## Sunnyside Cogeneration Associates

RE: DOGM Permit Amendment Application  
 Sunnyside Cogeneration Associates  
 Sunnyside Refuse and Slurry C/007/035

**Title:** Excess Spoil Disposal Area # 2 Design Revision

Adjust design slope of disposal area to increase capacity

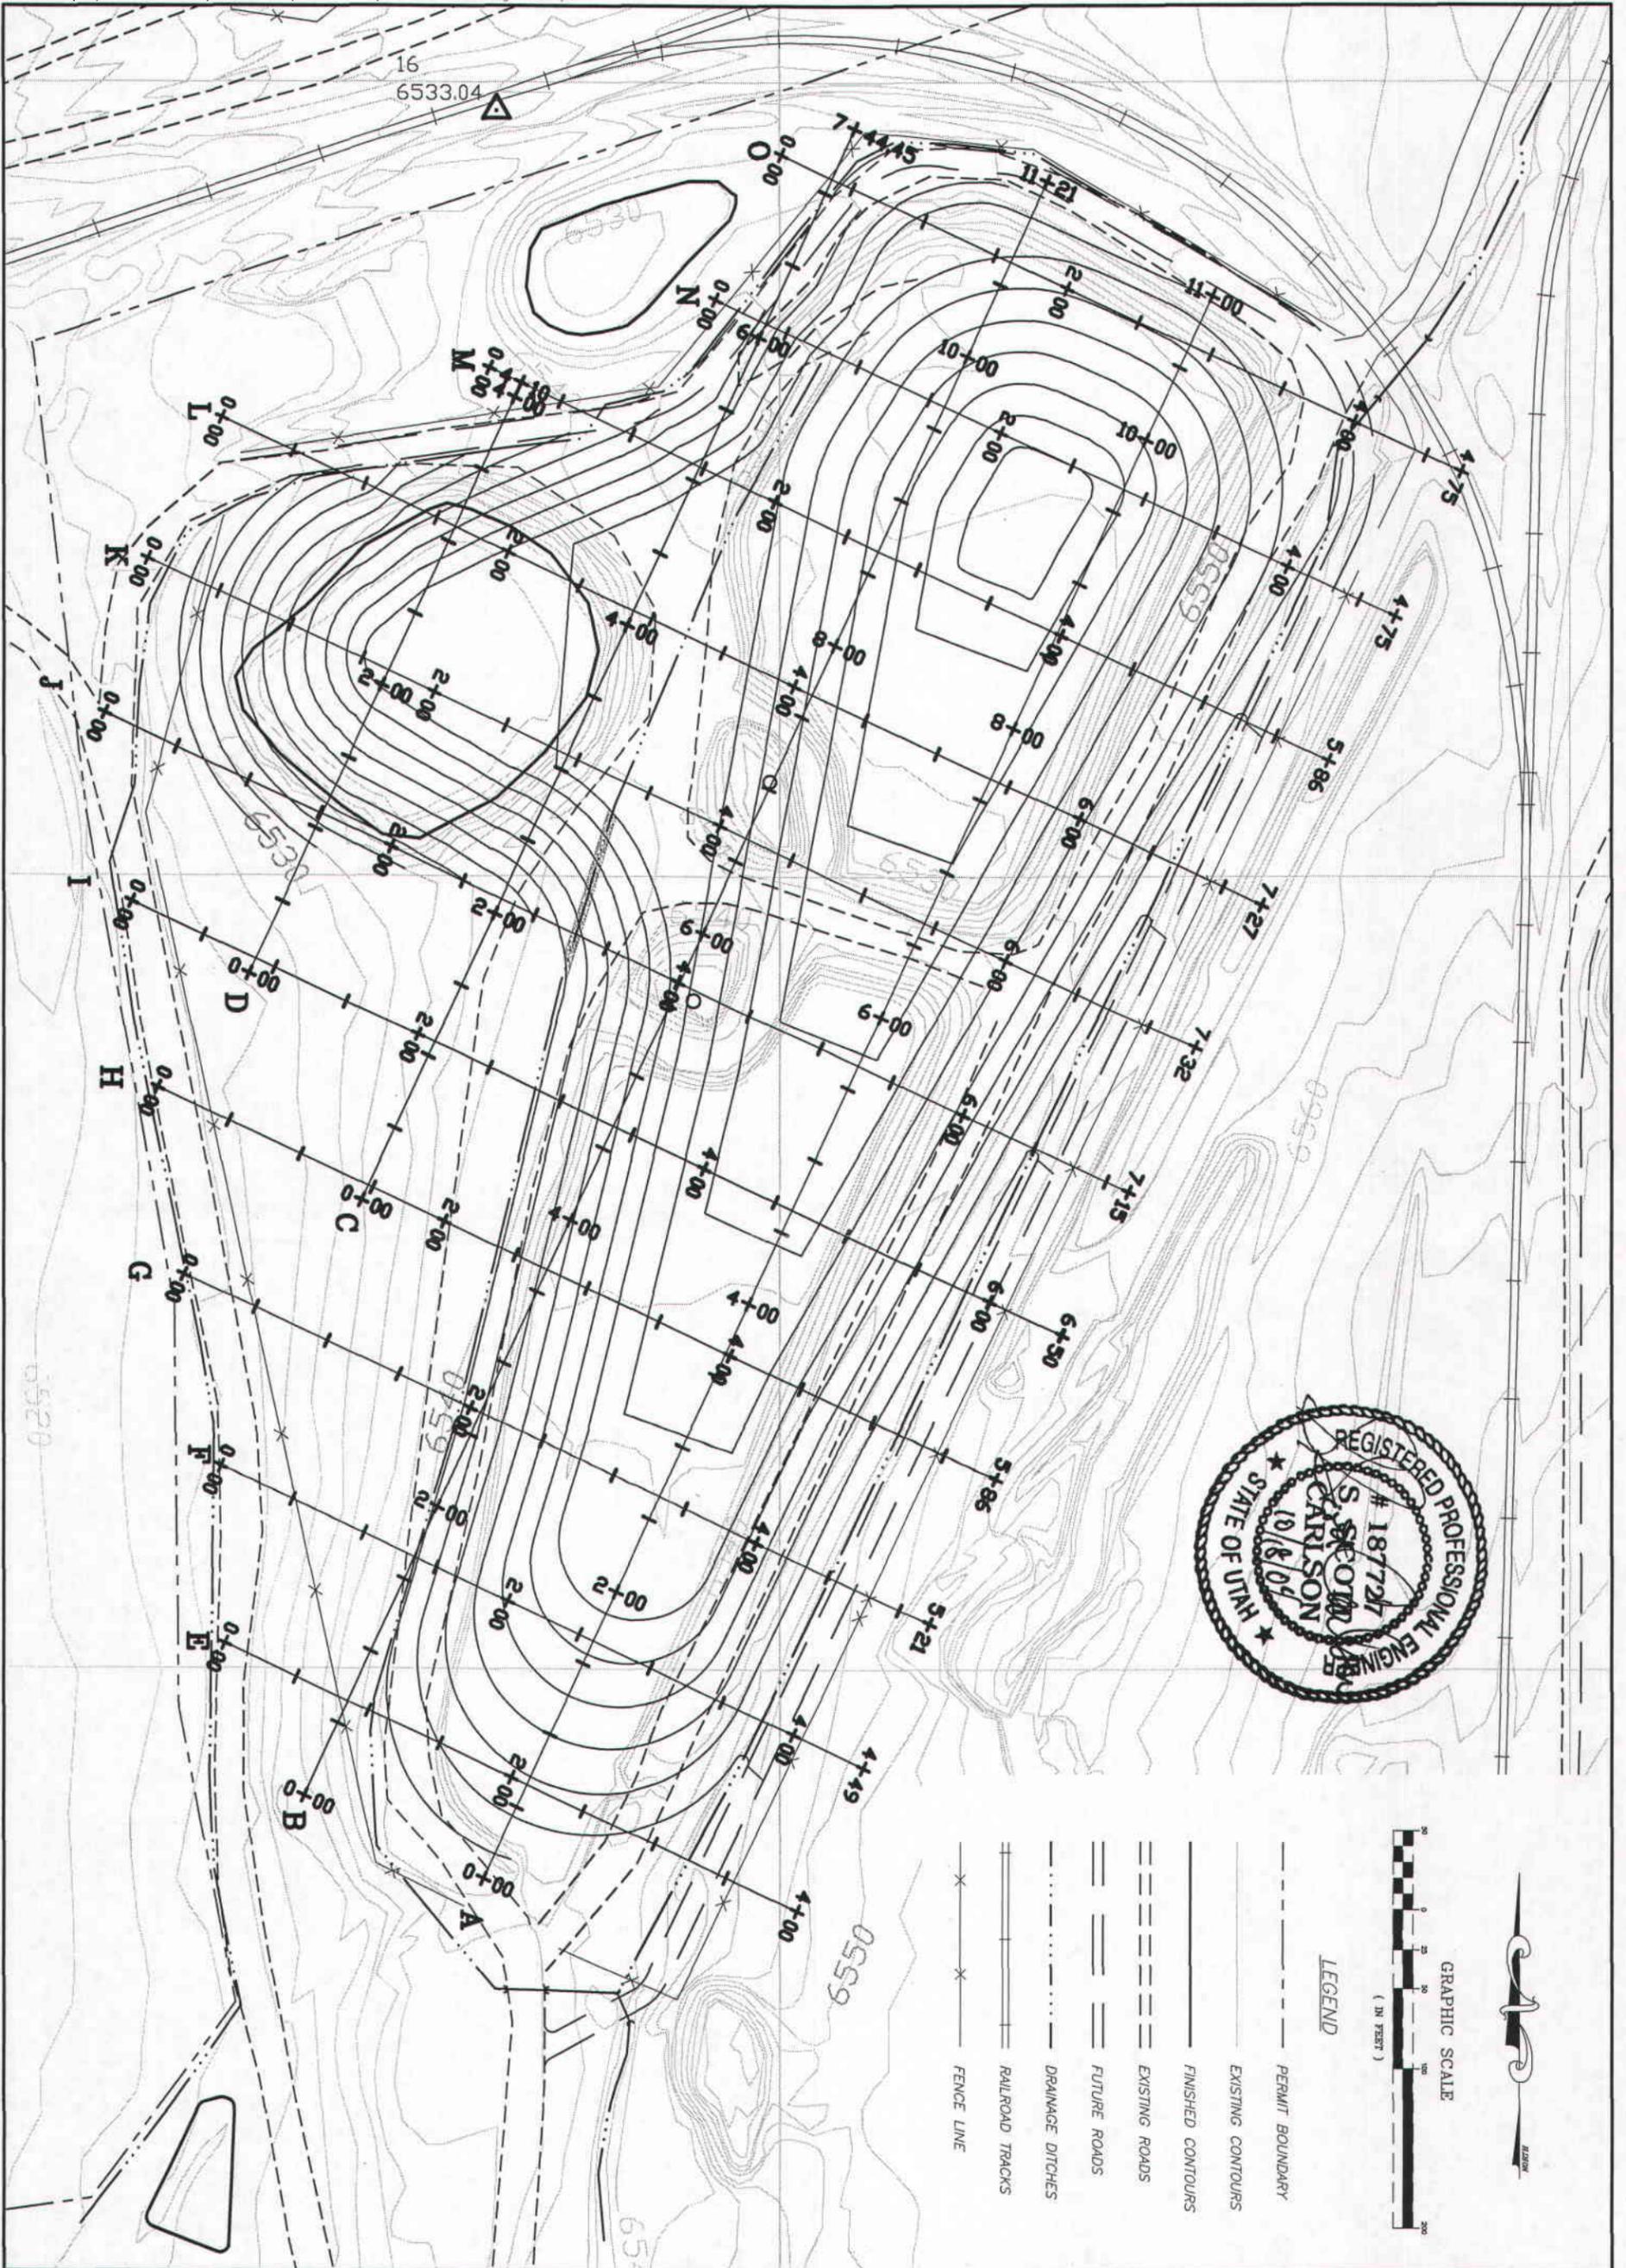
This amendment addresses proposed revisions to the slopes of Excess Spoil Disposal Area #2. This revision is being made to increase storage capacity of the disposal area. We did not prepare new hydraulic calculations on the basis that the surface area is not changing. Hydraulic calculations for this area can be found in SCA's permit No. c/007/035.
